**Re: Lot 12 Block 2 Volcano Cliffs SAD 227 Unit 2
5631 Cindercone NW
Request Permanent C.O. – Not Accepted
Engineer's Stamp dated: 1-19-18 (E10D042)
Certification dated: 9-21-18**

DRAINAGE AND TRANSPORTATION INFORMATION SHEET (REV 6/2018)

ENGINEER'S SEAL	5631 CINDER CONE DRIVE N.W.	DRAWN BY WCIWJ
DAVID SOULE NEW MEXICO 14522 REGISTERED PROFESSIONAL ENGINEER	GRADING AND DRAINAGE PLAN	DATE 1-19-17
1/19/18	Rio Grande Engineering 1606 CENTRAL AVENUE SE SUITE 201 ALBUQUERQUE, NM 87106 (505) 872-0888	21848-LAYOUT-1-18-18
DAVID SOULE P.E. #14522		SHEET #
		JOB # 21848

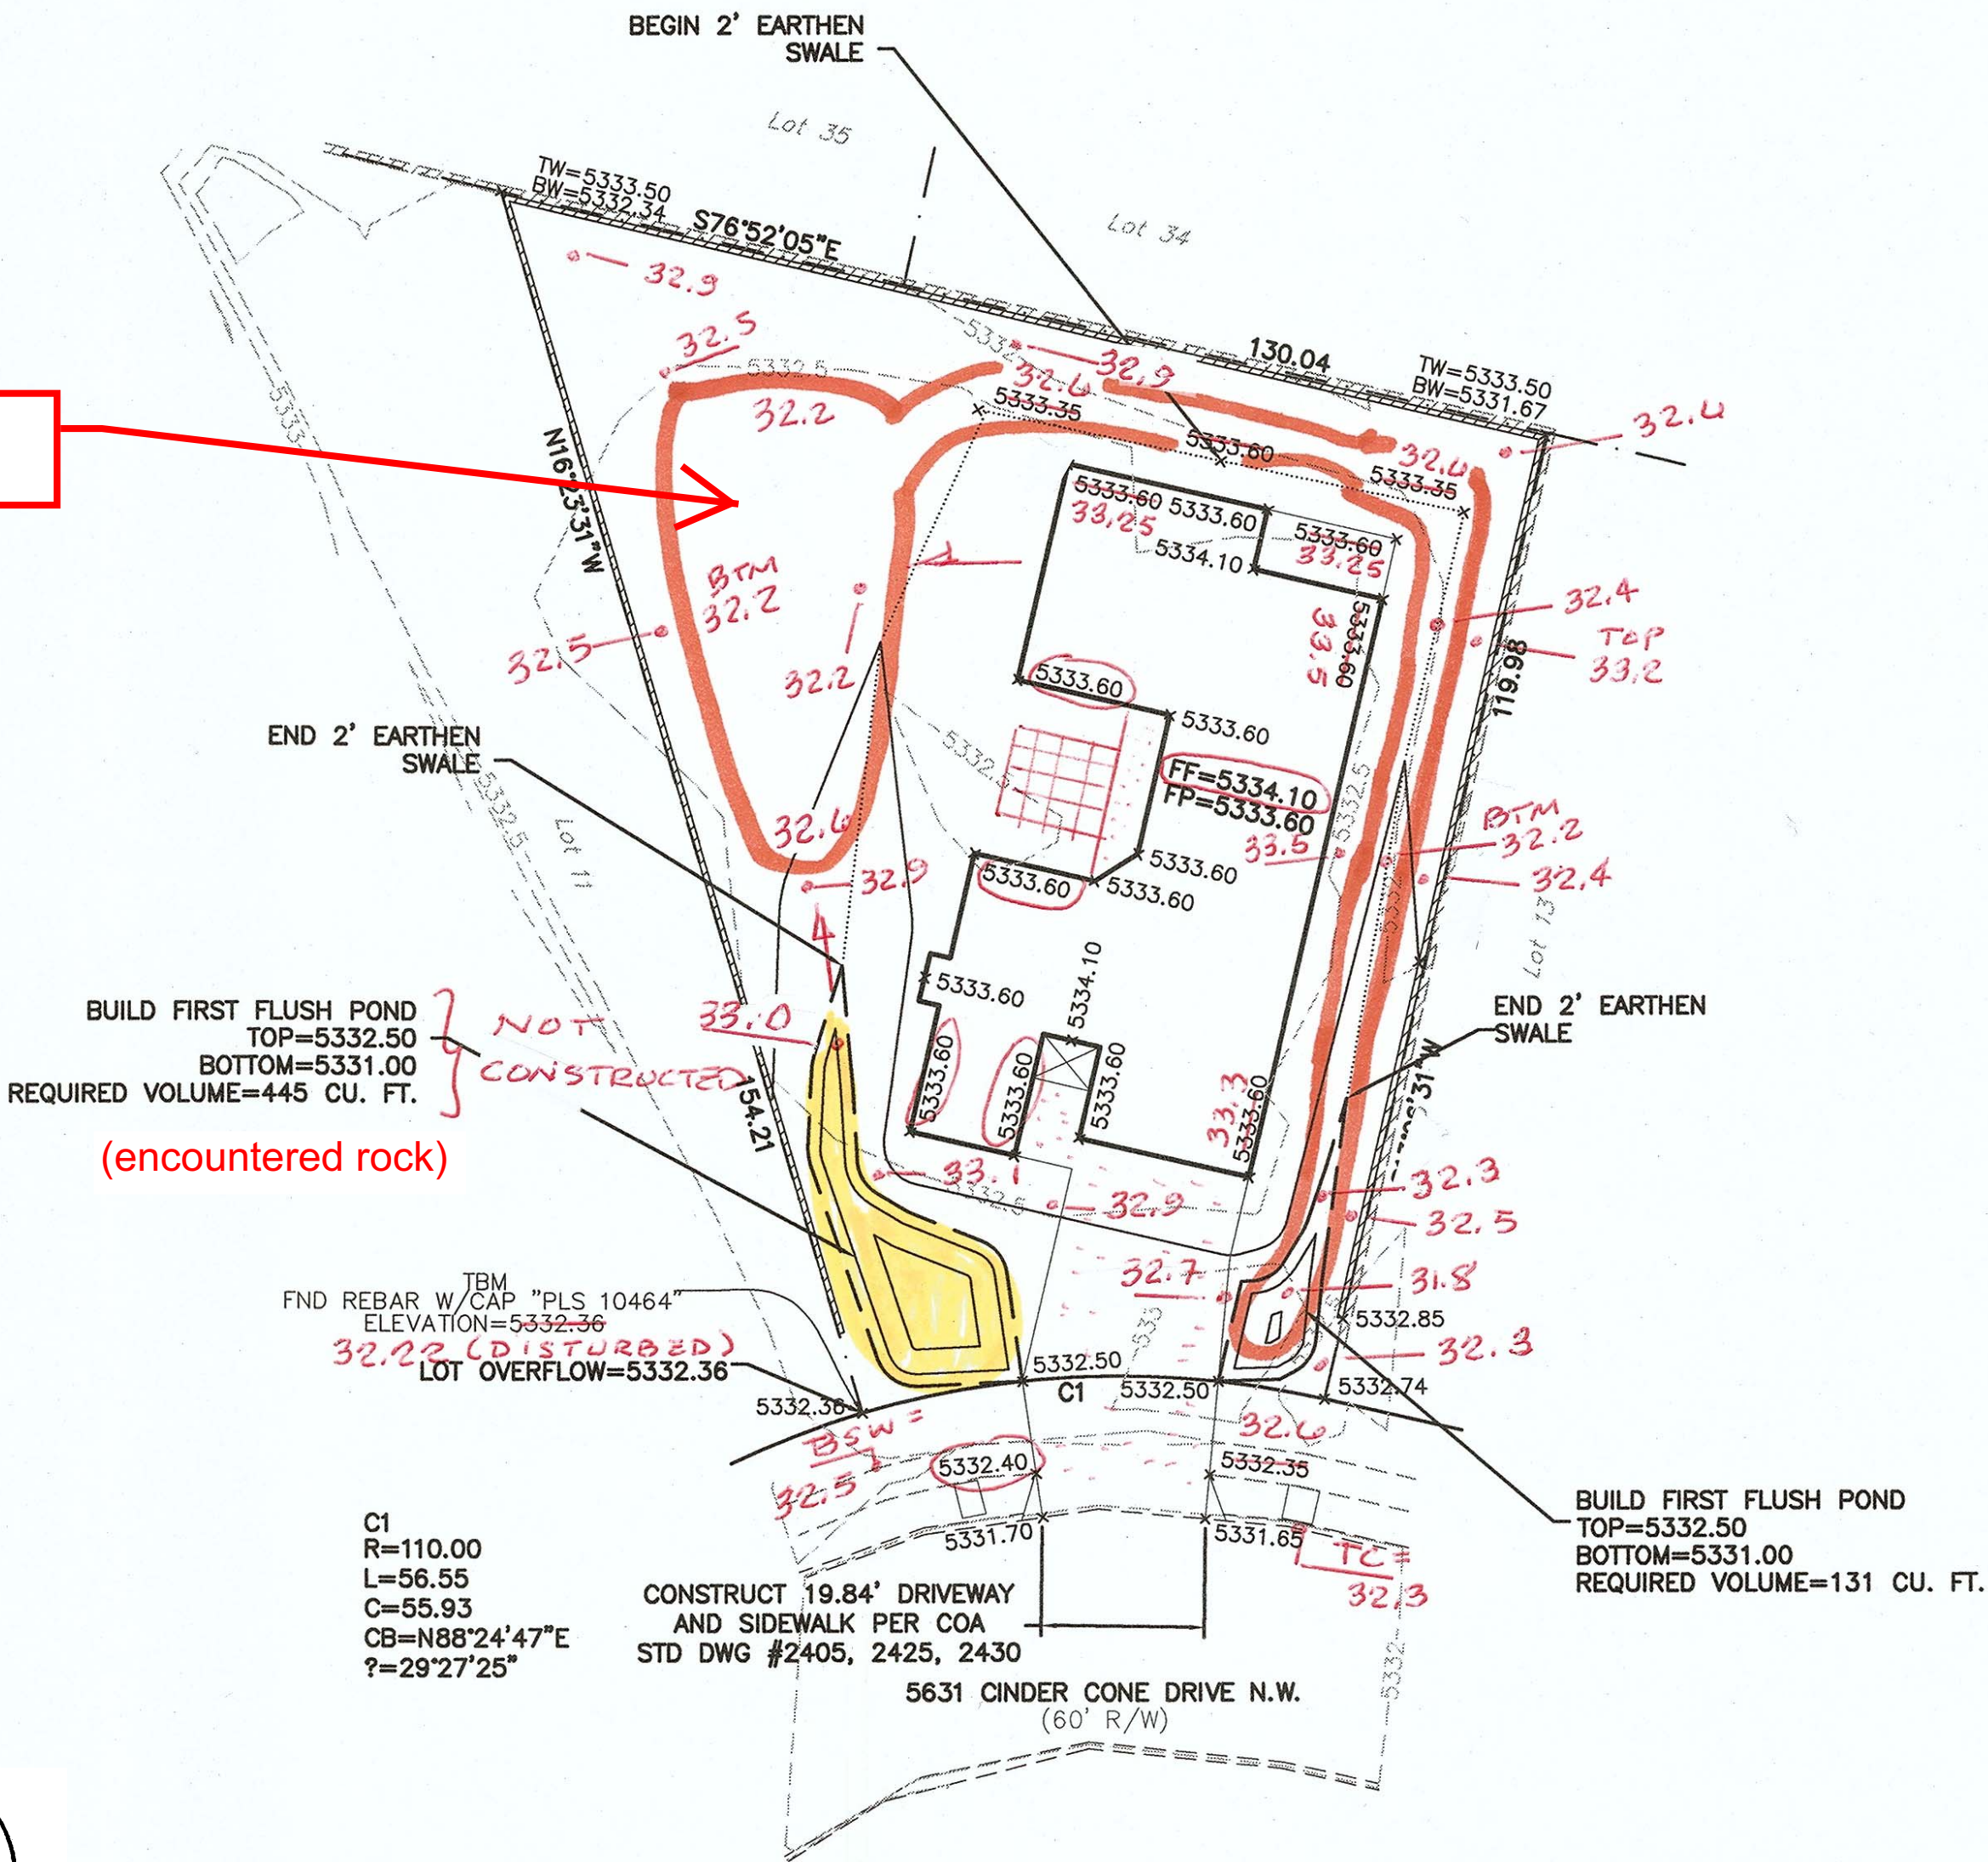
Based on the Certification received 9/24/2018, the site cannot be accepted for release of Certificate of Occupancy by Hydrology until the following comments are addressed.

- Remove the dirt piles and debris in the lot to the west of this address.
